REQUEST FOR PROPOSAL
Mansion Grounds Rehabilitation
State Preservation Board
RFP #809-22-0022
ADDENDUM #1
Date issued: June 17, 2022

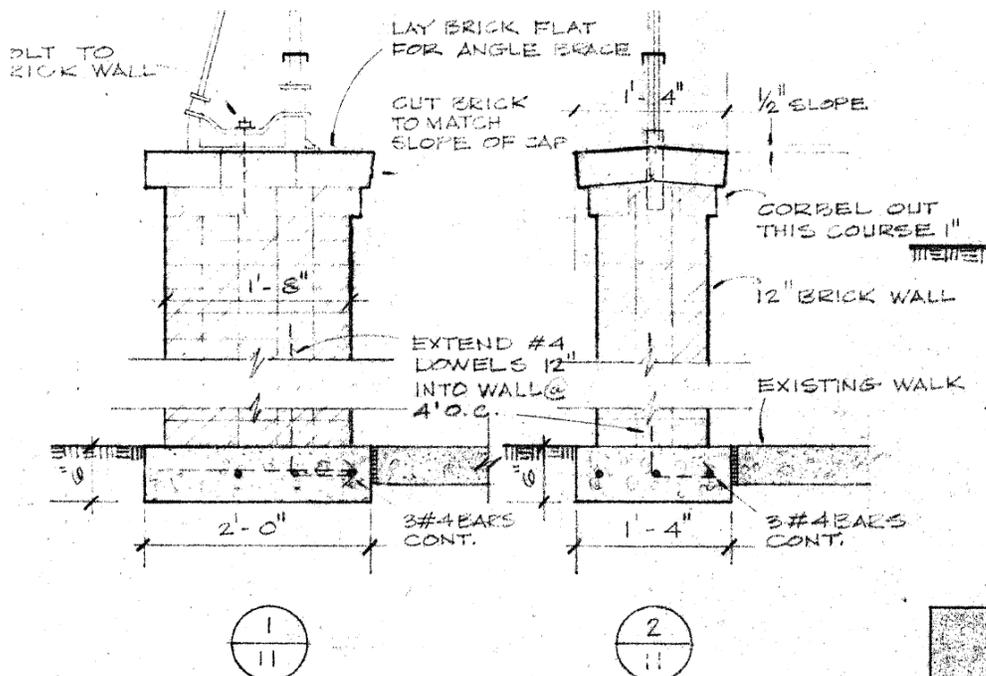
3. Connally Ramp: Is it ok to cut some of the roots on the tree along the ramp side? What is the process for interaction around existing tree roots?

SPB Response: It is ok to cut roots impacting work when they are less than 1" diameter, using disinfected hand tools. This should be only where absolutely necessary, not for convenience. Disturbance or roots and adjacent soil should be minimized. Since work will be done where this is existing, non-heaved sidewalks, the hope is that there will not be extensive or large roots impacting work. The SPB will have an arborist on call to consider larger roots.
